SCALE N.T.S. **DRAWING TITLE INTERIOR SEISMIC DETAILS AND MISC.**

CHANGE ORDER #257

TOWER II

CHILDREN'S HOSPITAL

DET. AT NORTH TOWER EXTERIOR WALL OPENING

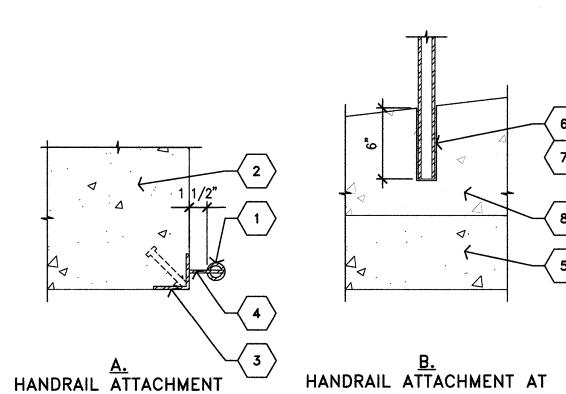
OPENING DETAIL 2. METAL CASING- SNAP-ON SYSTEM. PAINT OPENING

RFI 5436-

4. SEE A1, B1, B2/S6.40 FOR STUD TO PANEL CONNECTION DETAIL 5. SPACING BLOCK

SEE D1/S6.40 FOR STRUCTURAL
